REVISED RESPONSE TO REQUEST FOR ADDITIONAL INFORMATION

APR1400 Design Certification

Docket No. 52-046

RAI No.: 401-8402

Figure 1 –Locations for ECSBS connection

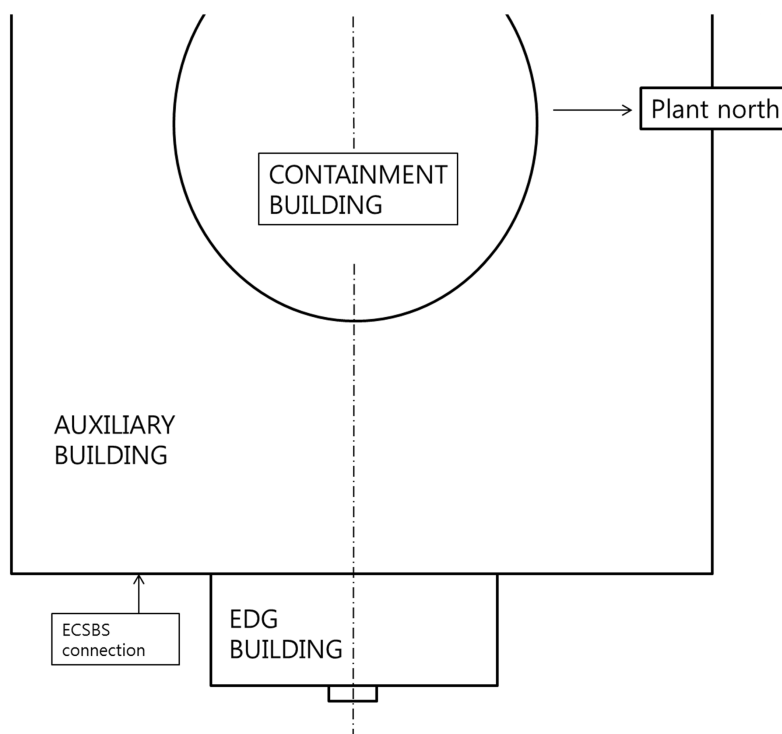
Technical Report APR1400-E-P-NR-14005-P does not contain simplified drawings to show how the FLEX strategy, using the emergency containment spray backup system (ECSBS), is used to maintain containment capabilities. The staff requests that the applicant provide a simplified drawing(s) that identifies the flow path to deliver water to containment. For example the drawing should depict plant piping, valves, pumps, water sources, power needs (as applicable), and any

associated connections (FLEX pump suction, FLEX pump discharge, and fuel supply) and support systems. The staff also requests that the applicant provide the quality classification of installed structures, systems, and components used to maintain containment capabilities. Additionally, the location for any connections should be identified.

The ECSBS can use an external water source from the RWT using the ECSBS FLEX pump, which is connected to the ECSBS via a fire siamese connection located outside of the [Auxiliary Building](#). Please refer to Figure 1 below for illustration. The ECSBS line runs inside the containment building from the fire siamese connection to the ECSBS nozzles.

The ECSBS FLEX pump is self-powered pump (diesel-driven). And the pump is connected to the RWT via a flexible hose on the suction side and is connected to the fire siamese connection via a flexible hose on the discharge side. Fuel is supplied from the diesel fuel oil day tank “A/B” as illustrated in Figure 6-6 of the Technical Report APR1400-E-P-NR-14005-P. [The quality classifications of installed structures, systems, and components used to maintain containment capabilities \(Containment Building, Auxiliary Building, and components of Containment Spray System\)](#) are described in DCD Tier 2 Table 3.2-1 (Page 1, 12, and 13 of 86) and Figure 6.2.2-1. A new schematic drawing (Figure 6-7) will be added to the next page of Figure 6-6 and Subsection 5.1.2.5.3 will be revised as indicated in the Attachment.
